Subject: Class 3 Permit Modification Request, Construction and Use of Hazardous Waste Disposal Units 11 and 12 for the Waste Isolation Pilot Plant Hazardous Waste Facility Permit Number: NM4890139088-TSDF

**Class 3 Permit Modification Request**

**Construction and Use of Hazardous Waste Disposal Units 11 and 12**

**Waste Isolation Pilot Plant  
Carlsbad, New Mexico**

**Figure D-7**  
**Designated Underground Assembly Areas**

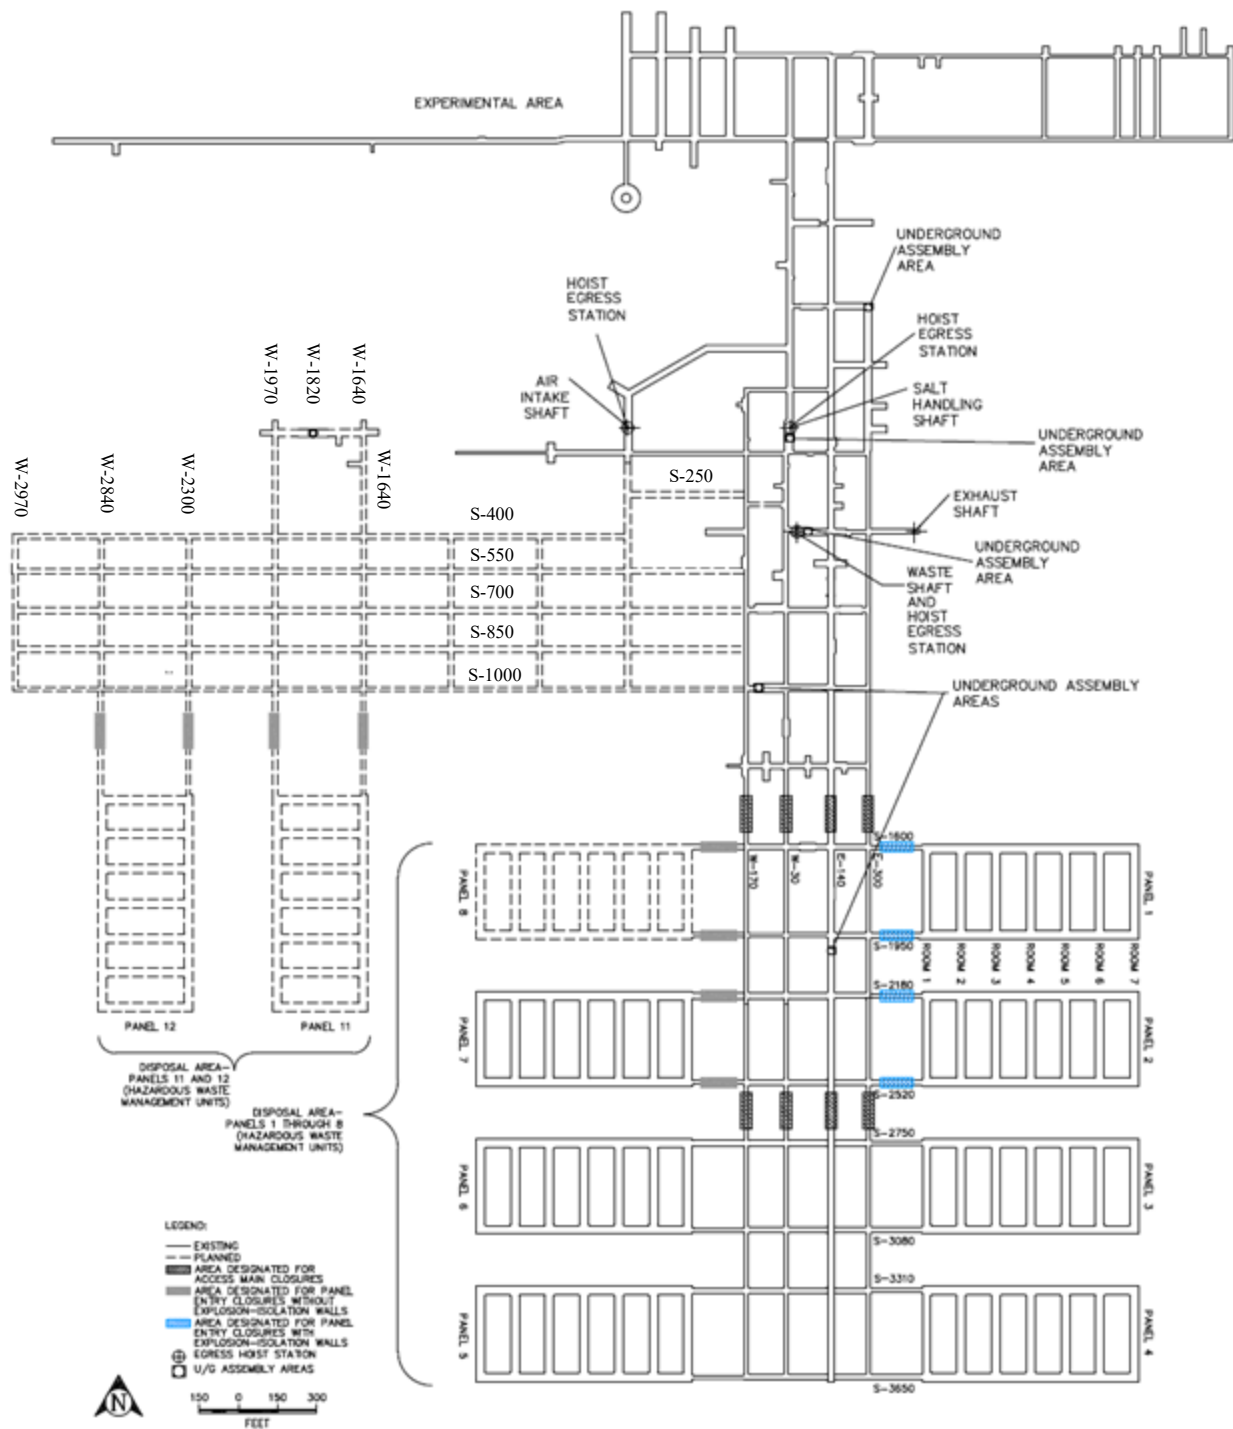
| Permit Part/Section                              | Impact  |
|--|---|
| Attachment D, Figures                            | Modified Figure D-7, <i>Designated Underground Assembly Areas</i> , to show the planned underground repository layout with the West Mains and Panels 11 and 12. This modification is needed to accurately depict the planned underground repository layout.   |

| Affected Permit Section                                 | Explanation of Change   |
|---|---|
| Attachment D, Figure D-7                                | Replaced figure to show the West Mains and Panels 11 and 12 in the underground assembly areas figure.   |

**Figure G-1**  
**Location of Underground HWDUs and WPC Locations**

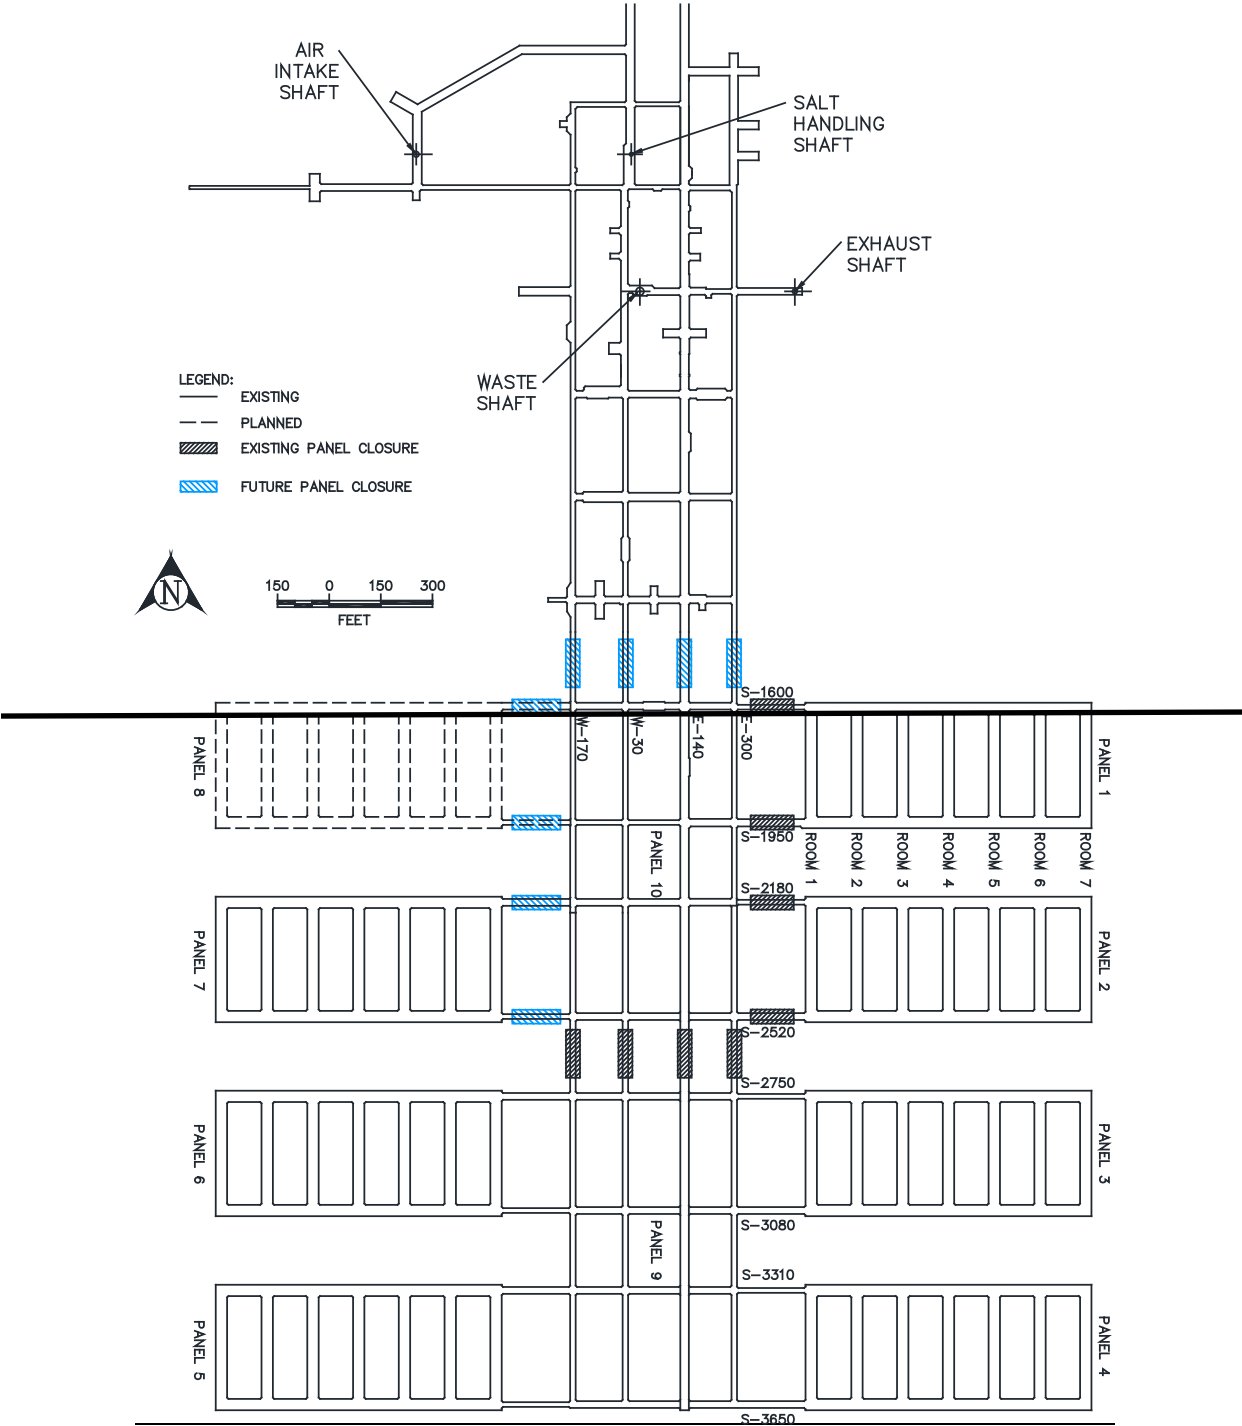
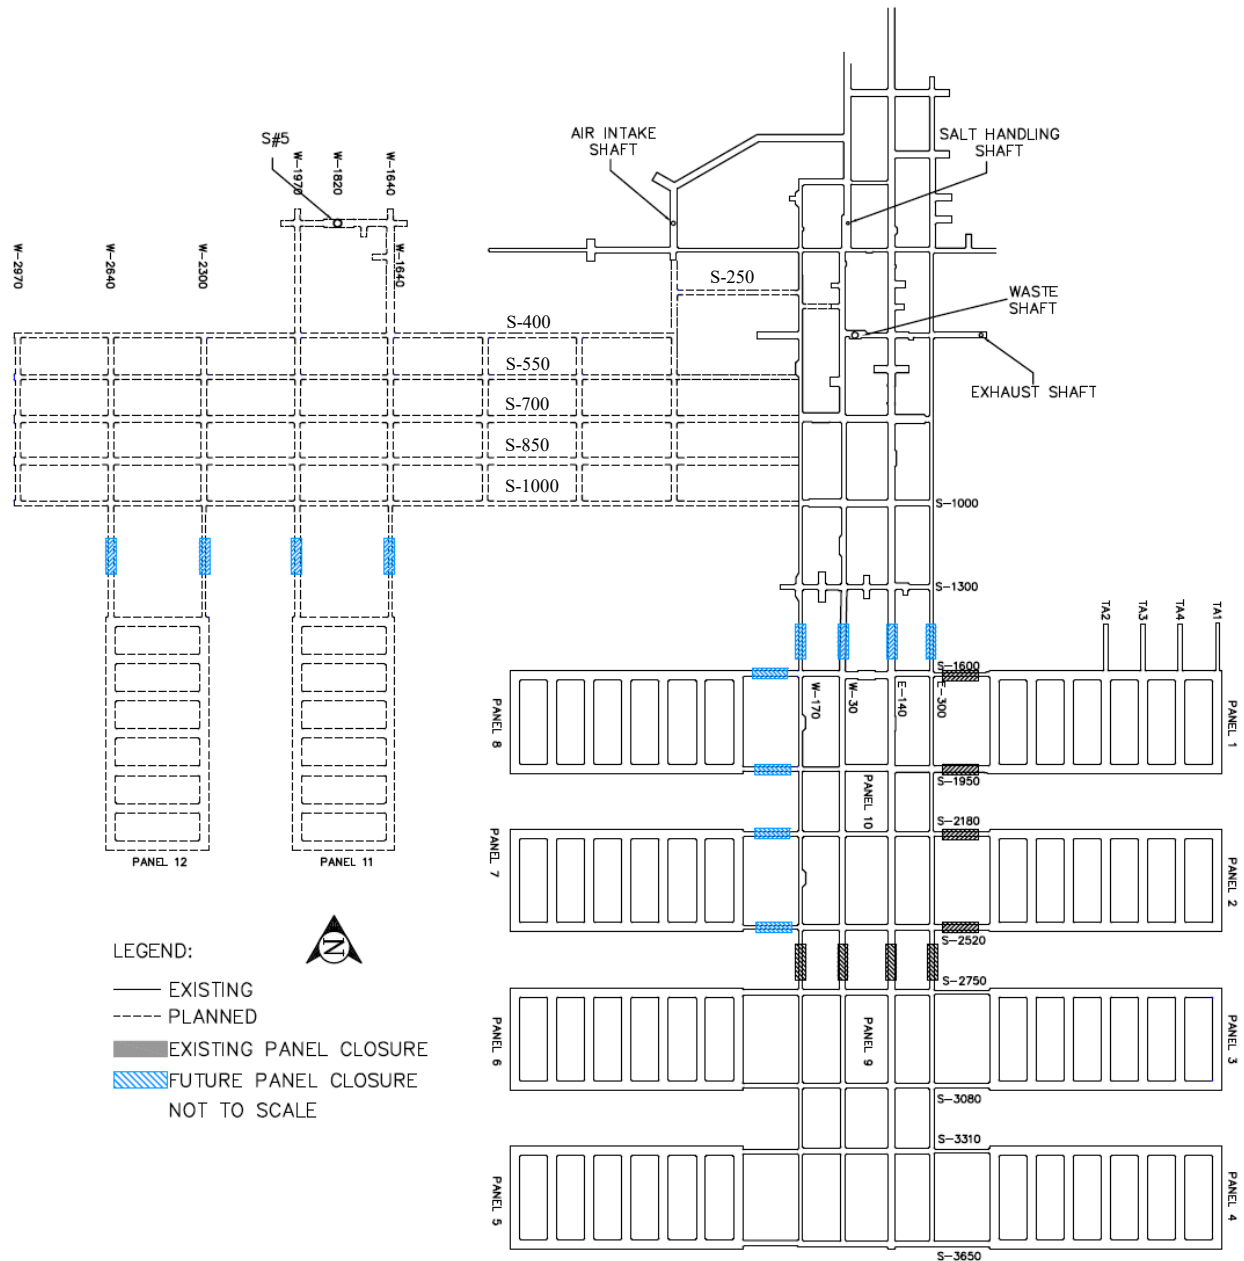
- Permit Attachment G, Figure G-1, *Location of Underground HWDUs and WPC Locations*, is being modified to include the location of the West Mains and Panels 11 and 12.

| Affected Permit Section        | Explanation of Change   |
|--------------------------------|---|
| Attachment G, Figure G-1       | Replaced figure to show the West Mains and Panels 11 and 12 along with the future panel closure locations.  |

Figure G-5  
Typical Disposal Panel

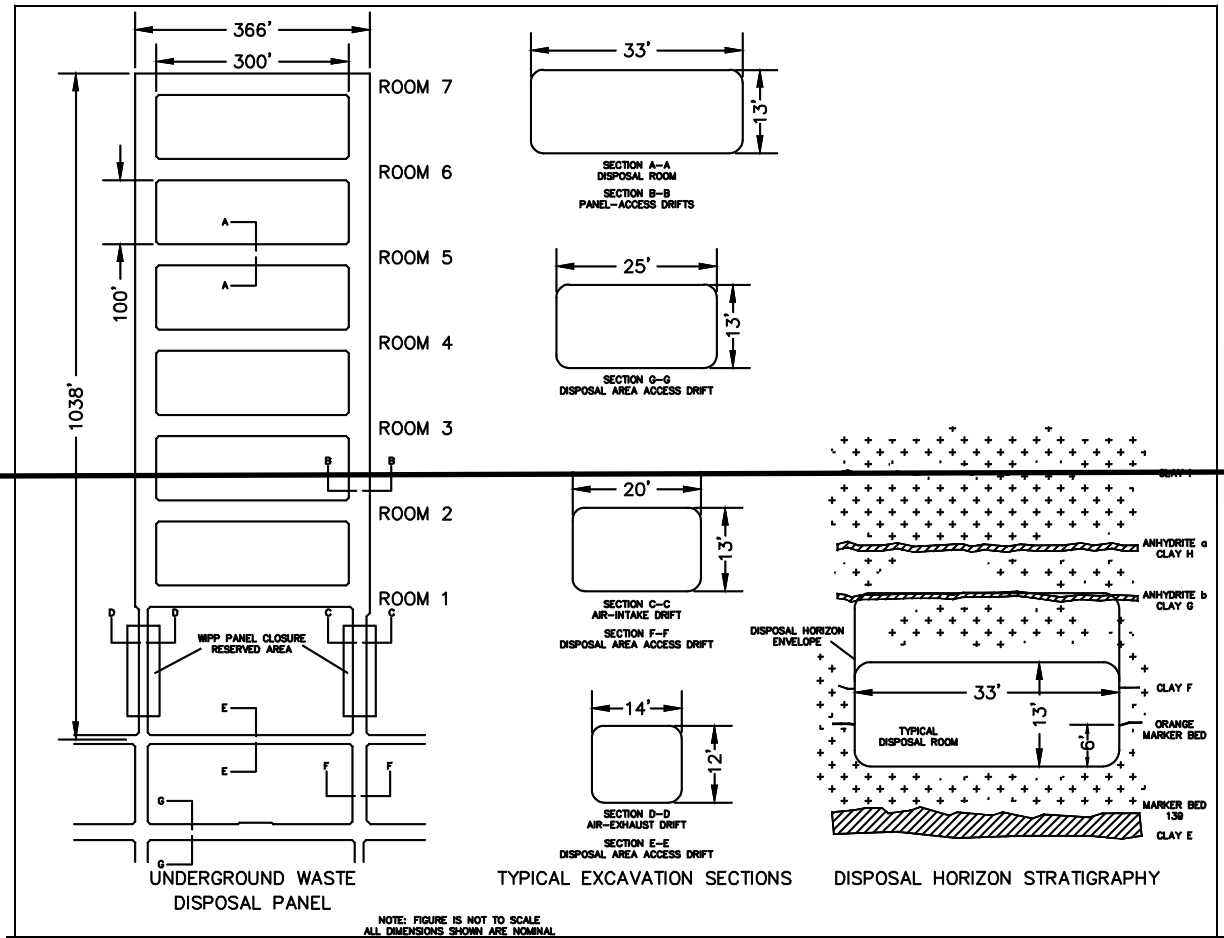
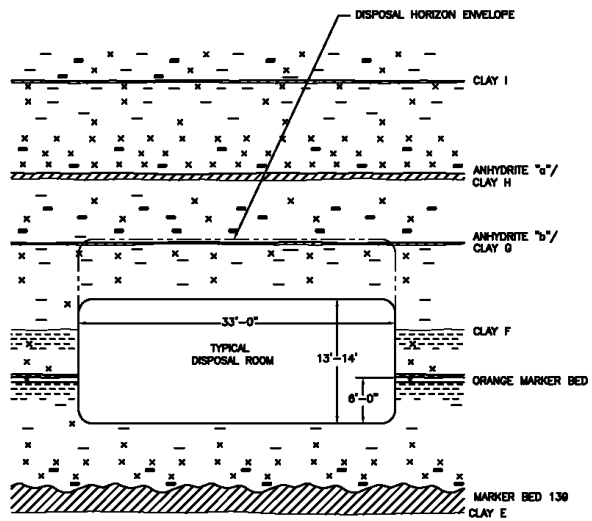
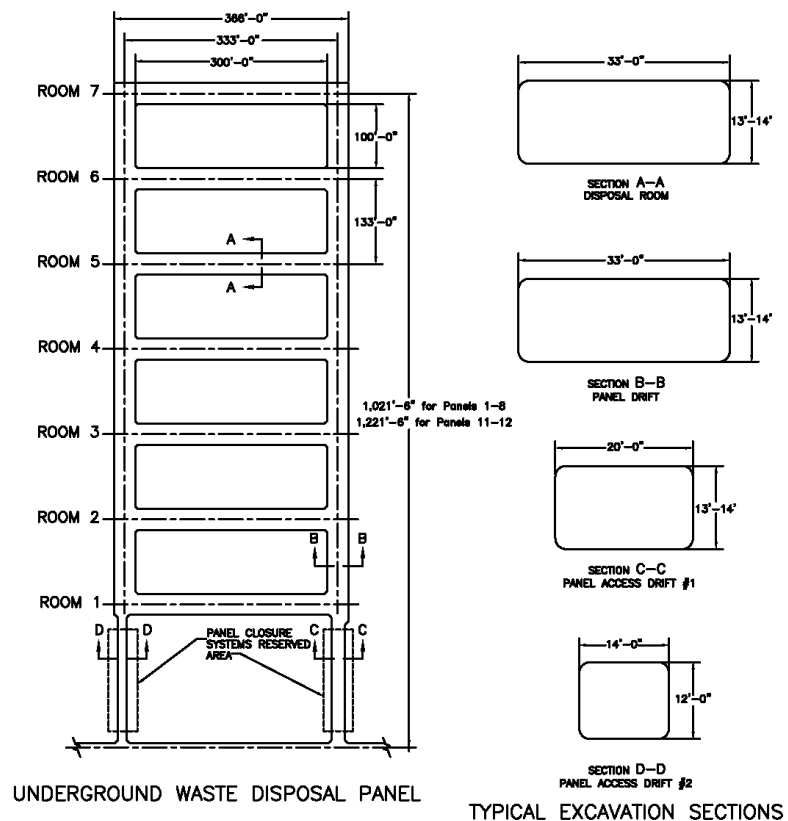
- Permit Attachment G, Figure G-5, *Typical Disposal Panel*, is being modified to show the length of the panel, including the abutment pillar, for Panels 1-8, as well as for Panels 11 and 12. Additionally the height of the disposal rooms and intake drifts is being modified on the figure to show that the nominal height is in a range of 13 ft-14 ft.

| Permit Part/Section           | Impact  |
|-------------------------------|---|
| Attachment G, Figures         | Modified Figure G-5, <i>Typical Disposal Panel</i> , to show the difference in the length of Panels 1-8 and Panels 11 and 12 based on the increased abutment pillar for Panels 11 and 12. Also modified the A-A' cross section to show the height of the disposal room as 13-14 feet. This modification is needed to accurately depict the panel dimensions.  |

| Affected Permit Section        | Explanation of Change   |
|--------------------------------|---|
| Attachment G, Figure G-5       | Replaced figure to show that the length of a typical panel is 1,021'-6" for Panels 1-8 and 1,221'-6" for Panels 11 and 12. Also modified the A-A' section to show the disposal room height at 13'-14'.  |
